Detailed Site Plan The HUB at College Park

DSP-19054

SUBJECT: Detailed Site Plan DSP-19054
The Hub at College Park

Figure 1: South Elevation

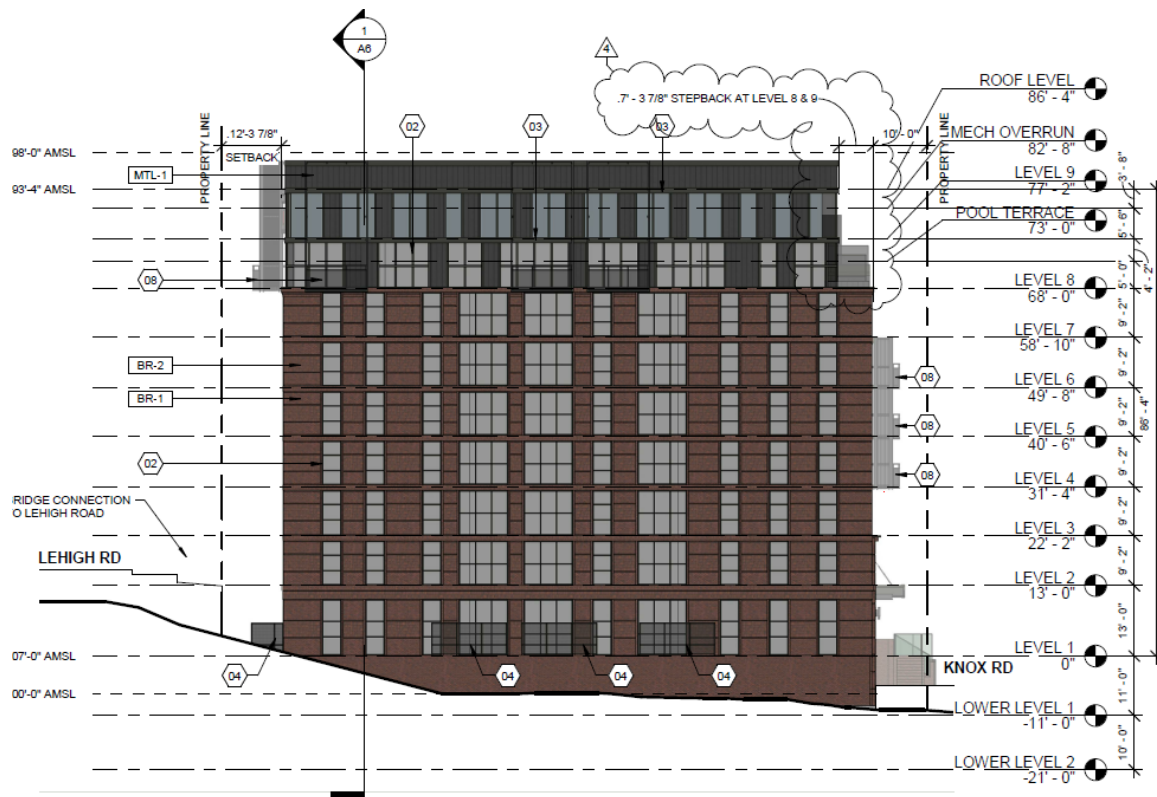
- d. **Page 246 – Building Form/Facades and Storefronts:** A building facing a street shall contain transparent windows covering 70 percent of the wall area and the applicant seeks to reduce the window area to 40 percent.

Due to the grade change across the site, the ground floor transitions between two building levels, which makes it difficult to strictly measure this standard. Furthermore, this standard is intended for commercial/retail uses on the ground floor, not residential. At the main entry level of this building, residential units occupy more façade area than commercial or public uses. Storefront windows and doors are not suitable for the residential units. The building’s design does incorporate appropriate residential windows for the units, which meet the intent of façade porosity at the ground level. Staff recommends **approval** of the applicant’s request for a modification, and the alternative design standard should not be detrimental to the intent of the plan.

4. **Page 246–Building Form/Facades and Storefronts:** Reduce transparent windows to cover 40 percent of the building wall facing a street.
 5. **Page 256–Sustainability and the Environment/Leadership in Energy and Environmental Design (LEED) Certification:** To allow for National Green Building Standard Silver certification.

- q. Correct the landscape schedule and Schedule 4.1 to reflect the landscape plan.
 - r. Consider replacing the metal panels at the 7th story (top floor) of the eastern side of the Knox Road façade with brick to provide a consistent 7 stories of brick on all façades of the building, and provide a prominent cornice treatment around the entire building at the 7th story, as requested by the City of College Park.

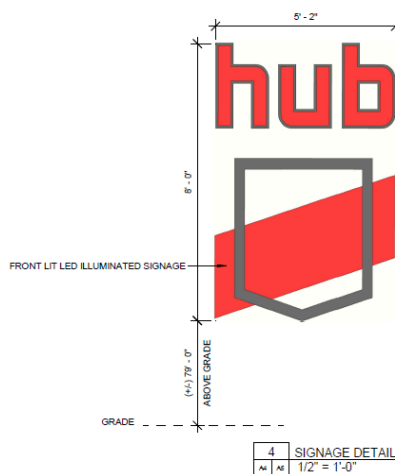
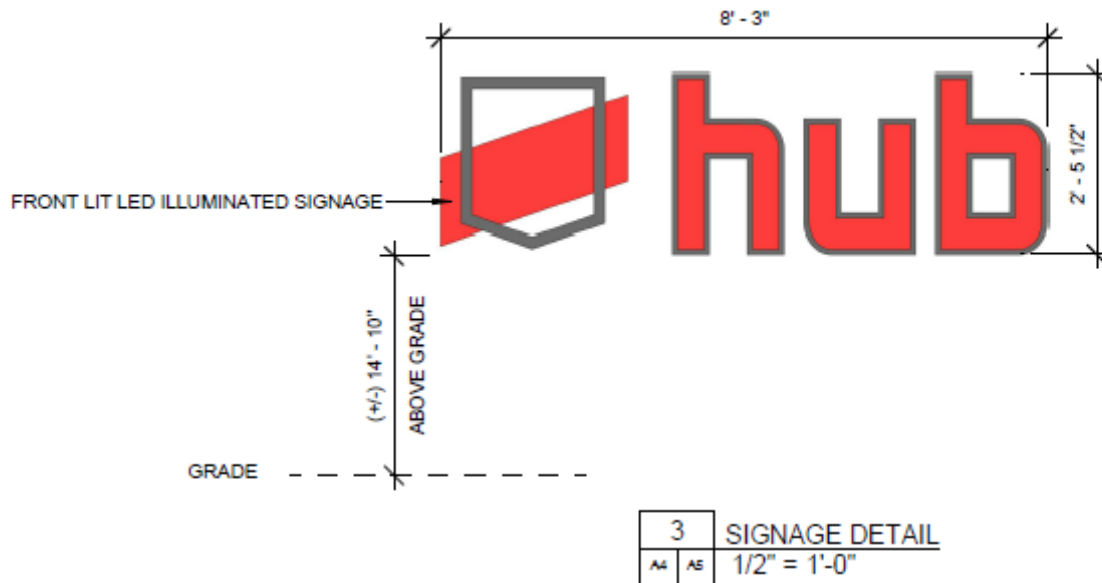
Signage—The applicant proposes two signs on the building. One will be located on the top northwest corner of the building and the other will be attached above the entrance canopy along Knox Road. The submitted sign plan for the project includes square footage, but not all the details necessary to fully evaluate conformance with the sign requirements of the D-D-O Zone. A proposed condition has been included in the Recommendation section that, prior to certificate approval, requires the applicant provide scaled details of all the signs and elevation drawings showing their location on the façades, in accordance with the applicable sign requirements.

- h. Provide a sign table listing the number of signs, size, material, lighting, and their location on the façades, in accordance with the applicable Development District Overlay Zone standards.

*Figure 9: Building sections showing the height compared to surrounding buildings.
Top: West elevation Bottom: South elevation*

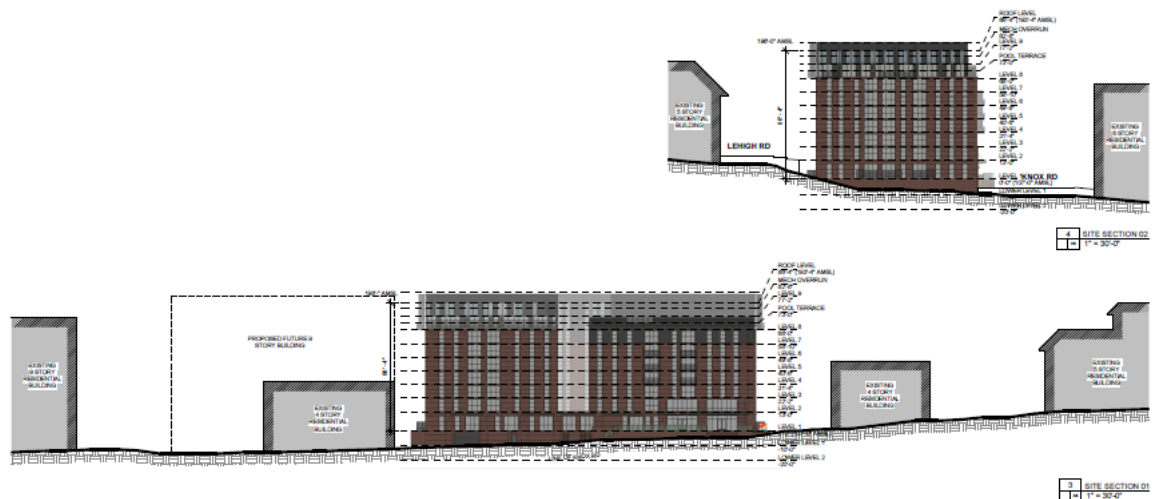
- a. **Page 234–Building Form/Character Area 5A/Walkable Nodes/Building Height:** To increase the height by three stories from the maximum six stories permitted in the Walkable Node to nine stories.

The proposed 9-story building height would conform to the Walkable Node (University) height provisions, but a 3-story amendment is required in the Walkable Node. The applicant's justification is that the plan and County policies promote density at this location because of the proximity to the University of Maryland campus. In addition, the topography of the site changes 20 feet from one end to the

other, and the proposed building will be the same height as the 6-story building to the south and 5-story building to the north. The building is twice as big as the existing buildings to the east and west, which are 4 stories. The applicant is also providing a 7-foot step-back to reduce the perceived height along Knox Road. Staff recommends **approval** of this amendment.

- A. APPROVAL of the alternative development district standards for:
 - 1. **Page 234–Building Form/Character Area 5A/Walkable Nodes/Building Height:** To increase building height from six stories to nine stories and to allow covered parking to be provided in the second layer.
